Reference: Valentine Gold Project – Project Refinements

**Project Refinements related to Caribou Mitigation,
Supplemental Information**

**Valentine Gold Project: Project
Refinements related to Caribou
Mitigation, Supplemental
Information**

January 2022

Figure 1-1 Updated Project Layout

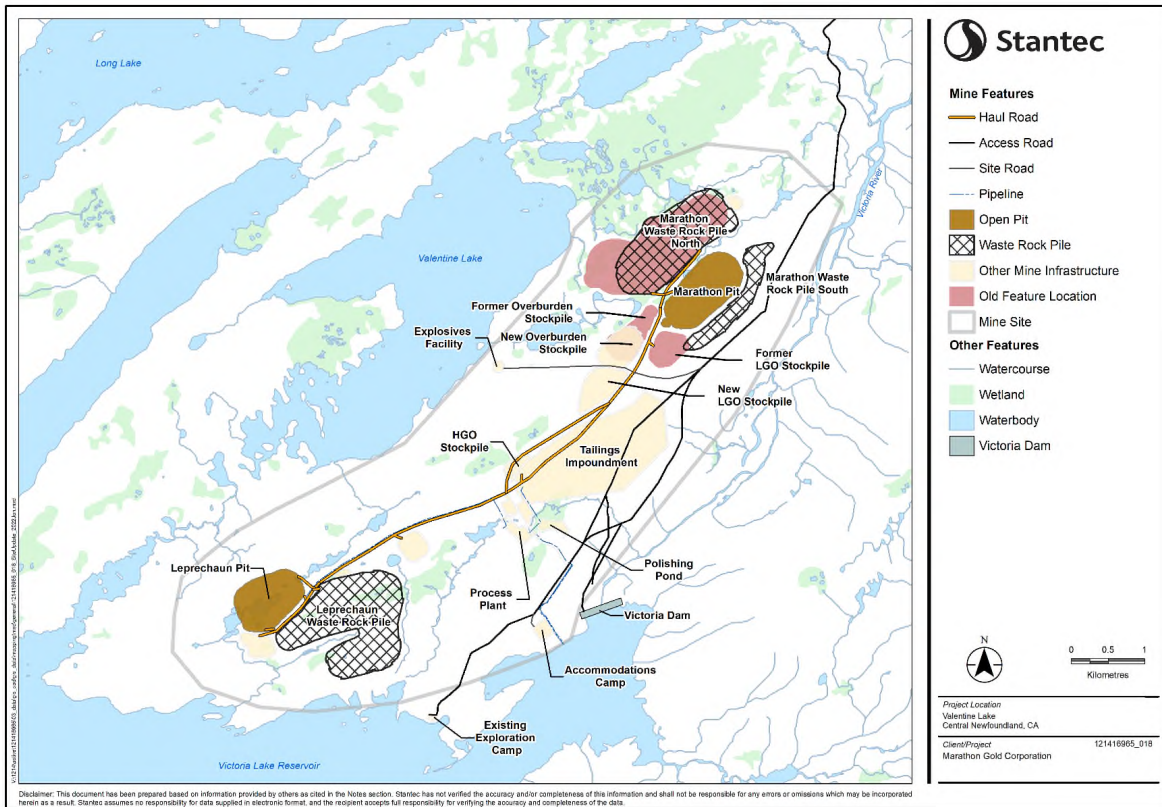
Based on these discussions, Marathon Gold Corporation (Marathon) has determined it to be technically and environmentally feasible to refine the layout/location of the LGO and overburden stockpiles and the waste rock pile (dividing the waste rock pile into two piles to be located to the northwest and southeast of the open pit). These refinements will provide wider and more direct travel paths within the primary migratory corridor both during operation of the mine, and through rehabilitation, closure and post-closure. Combining specific temporal mitigation measures (e.g., reduction in on-site activity during the sensitive migratory period) to reduce sensory disturbances with the change in the physical layout of the infrastructure set within the primary migratory corridor, it is expected that the migratory path will be more functional than that originally anticipated based on the site layout presented in the EIS and EIS Amendment. The refined site layout has been reviewed and discussed with NLDDFA-Wildlife Division and deemed to be an improved approach for migrating caribou. The refined site layout has also been discussed with other members of the Environmental Assessment Committee, as applicable.

Dividing the Marathon waste rock pile will create a combined footprint that is approximately 13% larger than that of the original waste rock pile. Approximately 75% of the Marathon waste rock pile footprint (90% of the volume) would be located on the northwest side of the pit and nearly 25% of the footprint (10% of the volume) southeast of the pit (See Figure 1-1). The proposed shape of the two waste rock piles will also form a permanent diversion around the open pit, reducing the potential that migrating caribou would directly encounter the open pit. In addition, the LGO stockpile will be shifted 450 m to the southwest and will increase in footprint from 20 hectares to 25 hectares (a 25% increase). The overburden stockpile will also be shifted approximately 125 m to the southwest, with the footprint being reduced by approximately 10%. The refinements to the stockpiles and waste rock pile will also require adjustments to the water management infrastructure associated with these Project features as further discussed in Section 2.2. Note that all the proposed Project refinements occur within the Project Area assessed in the EIS.

As shown in Figure 1.1, a portion (25% of the area) of the waste rock pile will be relocated to the southeast of the Marathon open pit. The portion of the waste rock pile to be relocated currently drains to MA-SP-02, which drains to Valentine Lake through a local tributary. Waste rock is not planned to be stored in the Marathon waste rock pile until later in 2023 and not in the pile located southeast of the open pit until early 2024. The proposed relocation of waste rock would eliminate the need for pond MA-SP-02 and the waste rock pile's southwest extent would be designed to follow the drainage divide between pond
